SUNDRY NOTICES AND REPORTS ON WELLS
Do not use this form for proposals to drill or to re-~~drill~~ abandoned well. Use form 3160-3 (APD) for such proposals.

8. Well Name and No.
MCINTYRE B 2

9. API Well No.
30-015-04217-00-S1

McIntyre B #2 Wellbore diagram

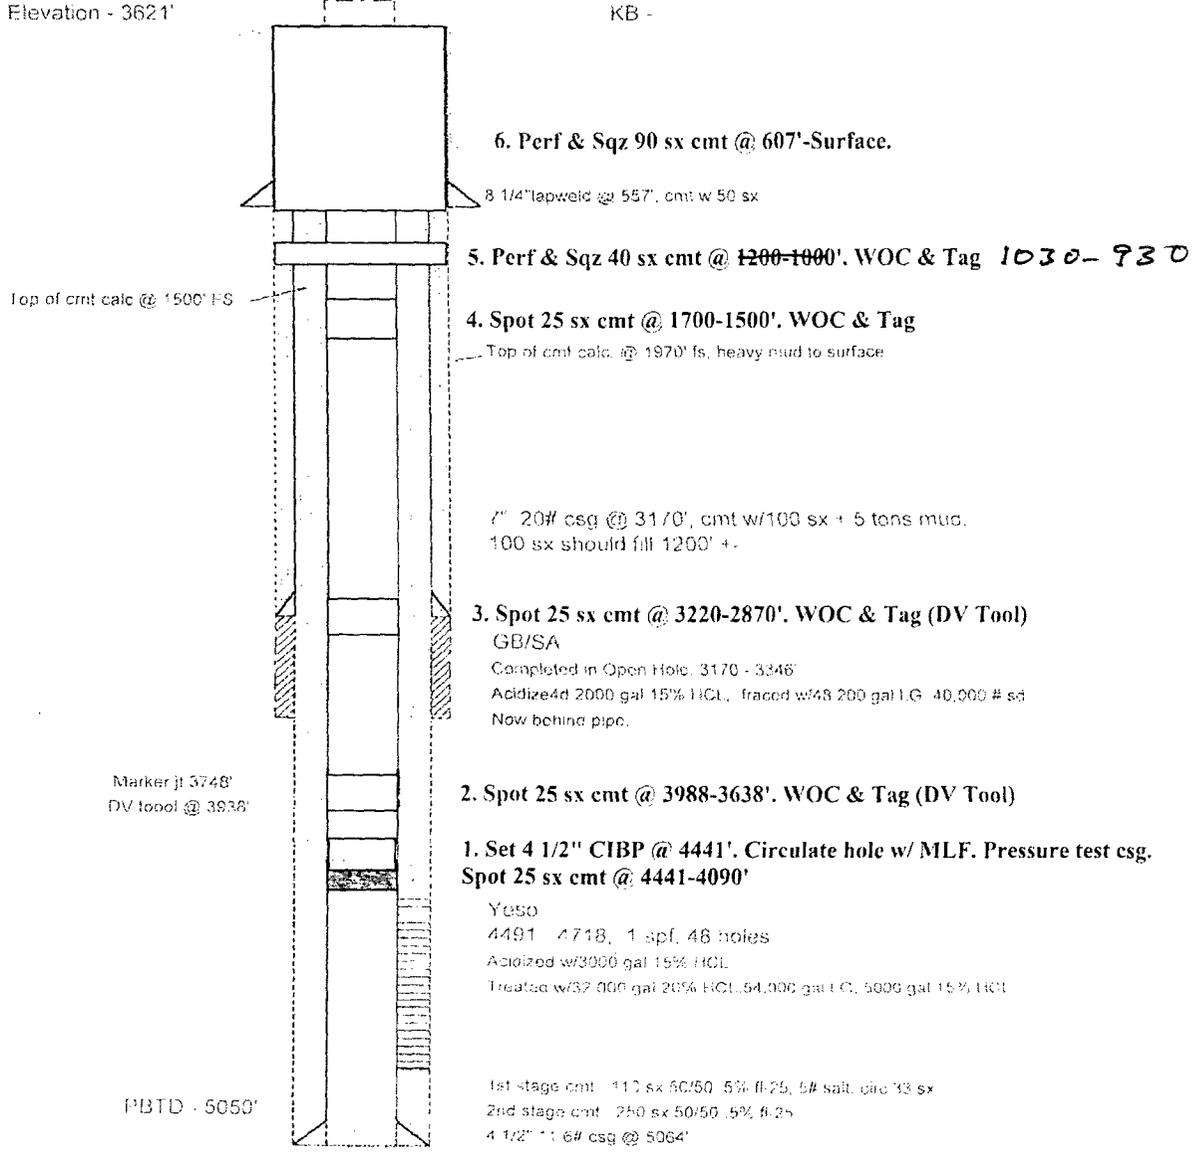
5. Perf & Sqz 40 sx cmt @ ~~1200-1000'~~ WOC & Tag 1030-930

Below ground level dry hole marker required
